The Sizewell C Project, Ref. EN010012

Comments on any additional information/submissions received at D5

Suffolk County Council Registration ID Number: 20026012

Deadline 6

Figure 3.1: Barrack Square Journey Time Validation Results (15:00 - 16:00)

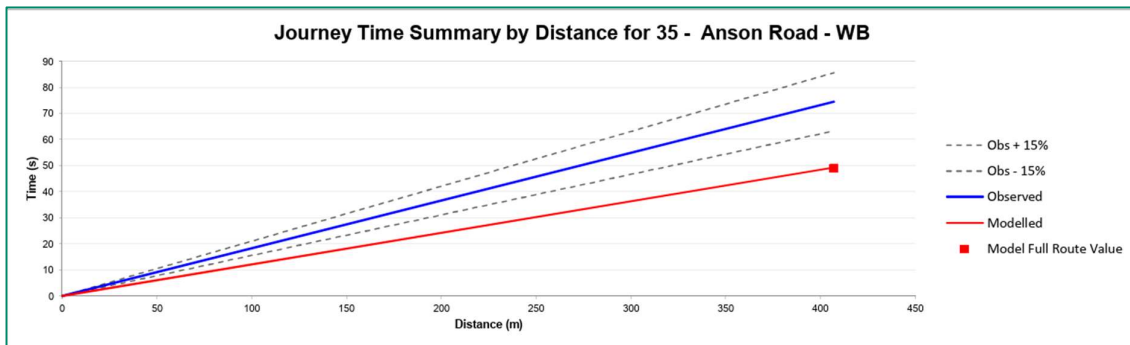
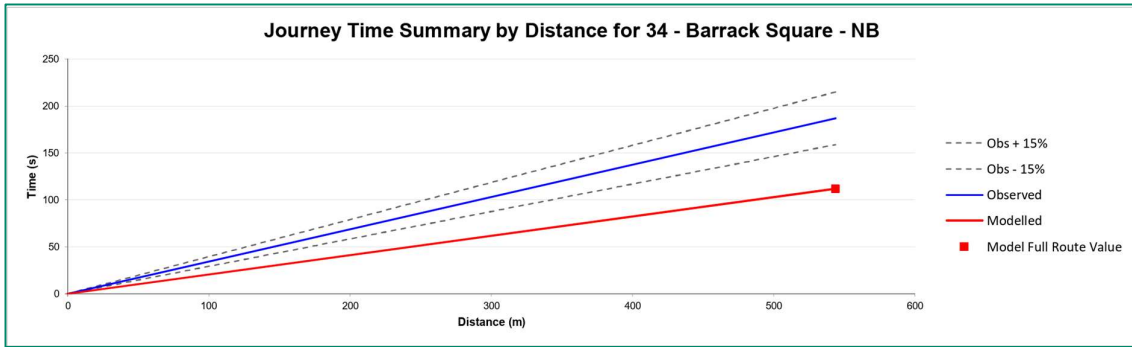
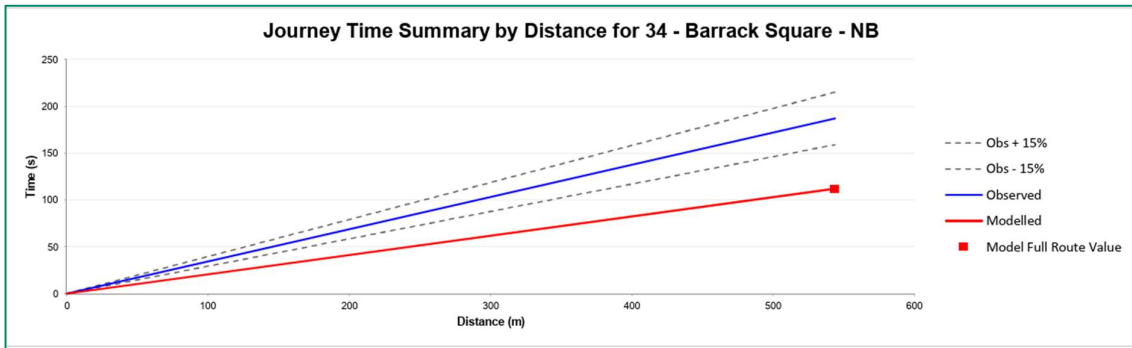
3.15 As shown, the modelled journey times on both the Barrack Square and Anson Road approaches was found to be below the observed journey times which indicates that the magnitude of congestion on these approaches is not being accurately represented in the Base Year and forecast models. Cognisance of this should be taken when viewing the results of the forecast year congestion on these approaches; particularly when assessing the requirement for any future mitigation measures as the congestion shown on these approaches in forecast years may only just exceed what is currently experienced in reality due to underestimation.

Figure 3.7: J21 - A12 (N) Queue Lengths (16:00 - 17:00)

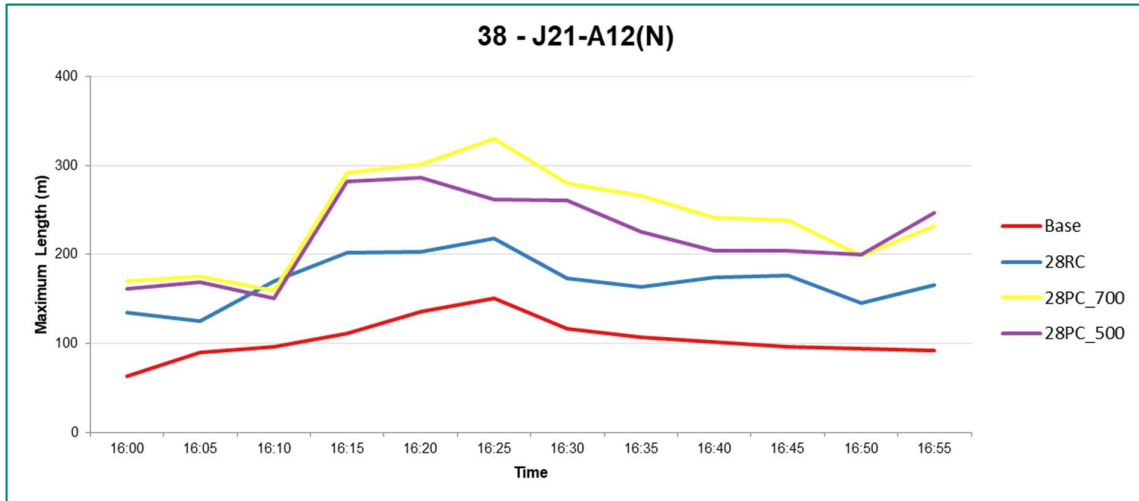
3.25 In the Peak Construction (700 two-way HGVs) scenario the maximum queue length extended over 200m from approximately 16:15 onwards, reaching a maximum of approximately 330m at 16:25. As demonstrated through the average queue length results presented by SZC Co., there is a sustained level of queuing of over 200m between 16:00 and 17:00 which indicates that this approach is sensitive to increases in traffic using the roundabout.

Figure 3.8: J25 - A12 (S) Queue Lengths (08:00 - 09:00)

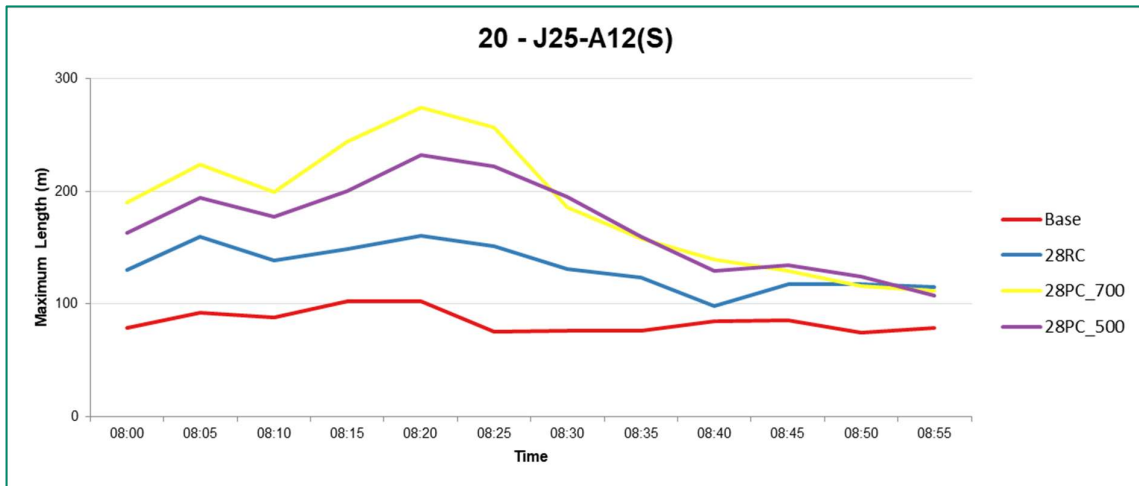
3.27 In the Peak Construction (700 two-way HGVs) scenario the maximum queue length extended to approximately 270m at 08:20 which was over 100m greater than in the 2028 Reference Case. In the AM period there is a large volume of northbound Sizewell C traffic which is likely the cause of this increase as the approach is already shown to be over capacity.

Figure 3.10: J26 - A12 (S) Queue Lengths (08:00 - 09:00)

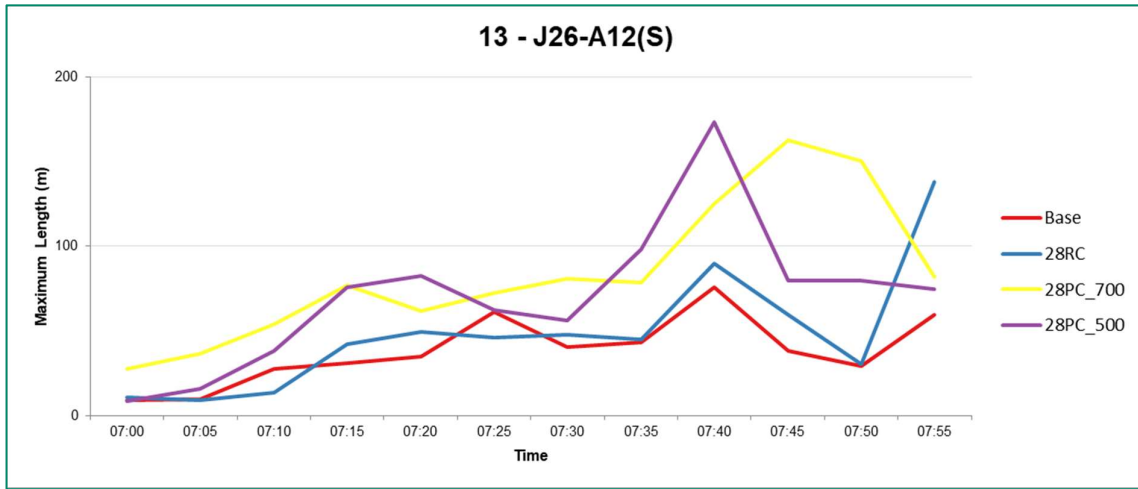
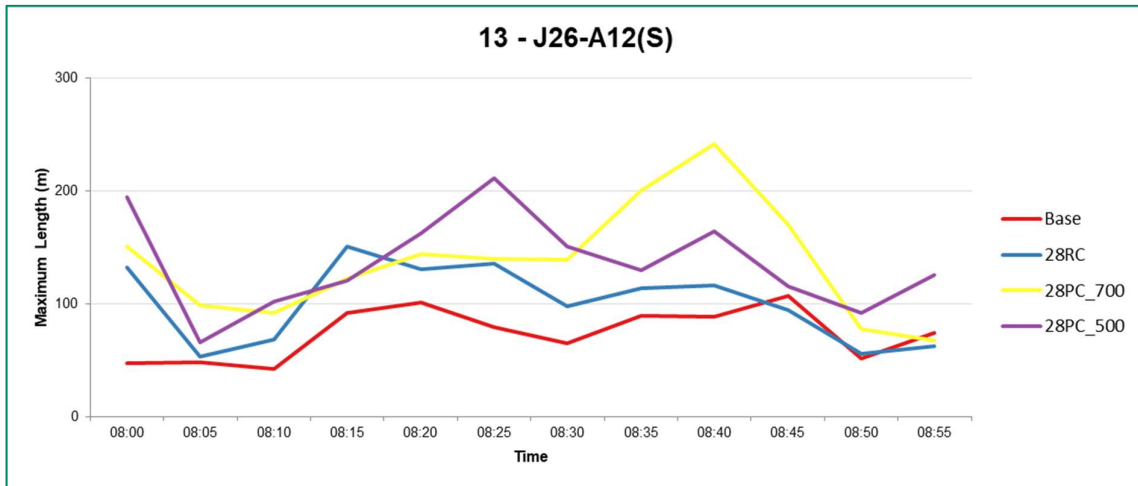
3.29 Due to the increase in northbound traffic in the AM period and the single lane approach for northbound vehicles at this junction, it was found to be very sensitive to increases in traffic. Between 07:00 and 08:00, the maximum queue length in the 700 two-way HGV movements scenario was approximately 163m at 07:45 compared to only 60m in the 2028 Reference Case at this time. Between 08:00 and 09:00, the maximum queue length was approximately 241m in the 700 two-way HGV movements scenario at 08:40 compared to 116m in the 2028 Reference Case at this time.

3.30 Furthermore, given the minor differences in queuing between the 500 two-way HGV movements and 700 two-way HGV movements scenarios, the junction also appears to be sensitive to the rate in which vehicles arrive at the northbound approach as queues are shown to spike at different times.

Figure 3.11: J26 - A12 (S) Queue Lengths (16:00 - 17:00)

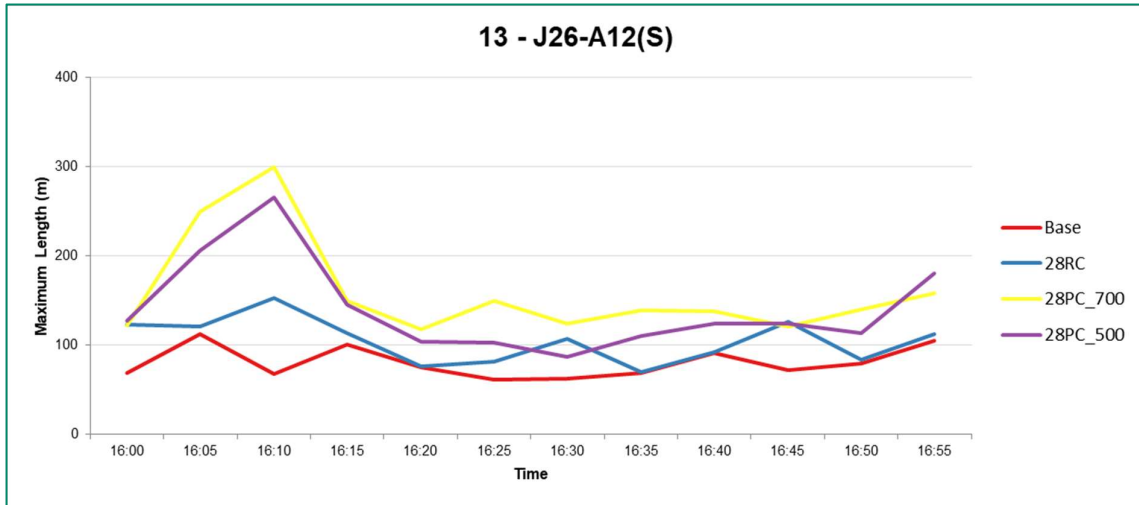
3.32 In the PM period at 16:10 there was a notable spike in queueing where the queue reached approximately 300m in the 700 two-way HGV movements scenario compared to approximately 150m in the 2028 Reference Case. Maximum queue lengths throughout the rest of the hour were largely similar to what was observed in the 2028 Reference Case.

Figure 3.12: J27 - A12 (S) Queue Lengths (08:00 - 09:00)

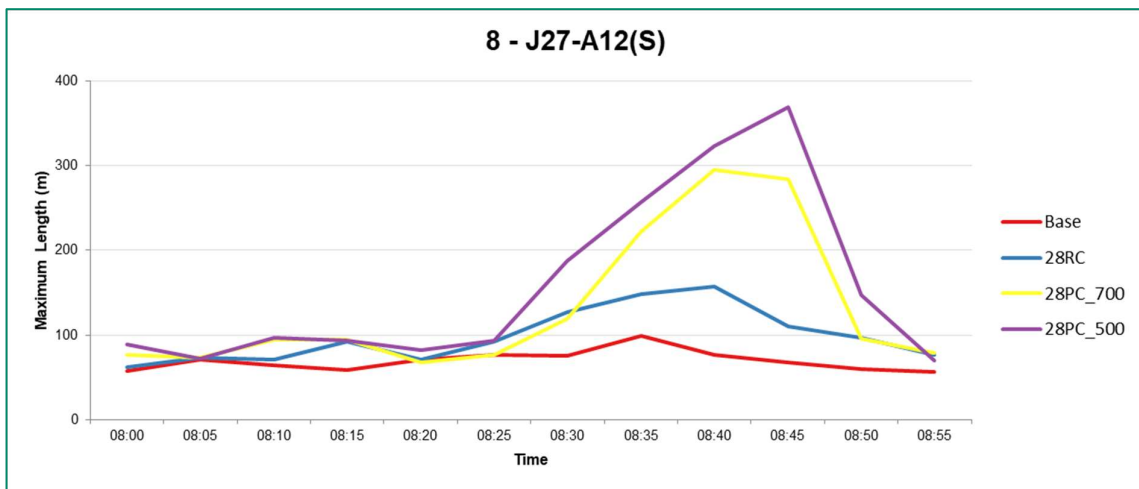
3.34 As shown, there was found to be a significant spike in queueing between 08:30 and 08:45 in the 700 two-way HGV movements as well as the 500 two-way HGV movements scenarios with peaks of 295m and 370m respectively. This is a significant increase compared to the 2028 Reference Case where the maximum queue length was 157m during this 15-minute period. It should be noted that prior to this approach to the junction, the A12 is only a single lane northbound, therefore any queueing which extends back to the single carriageway section would be worse than if it were all dual carriageway.
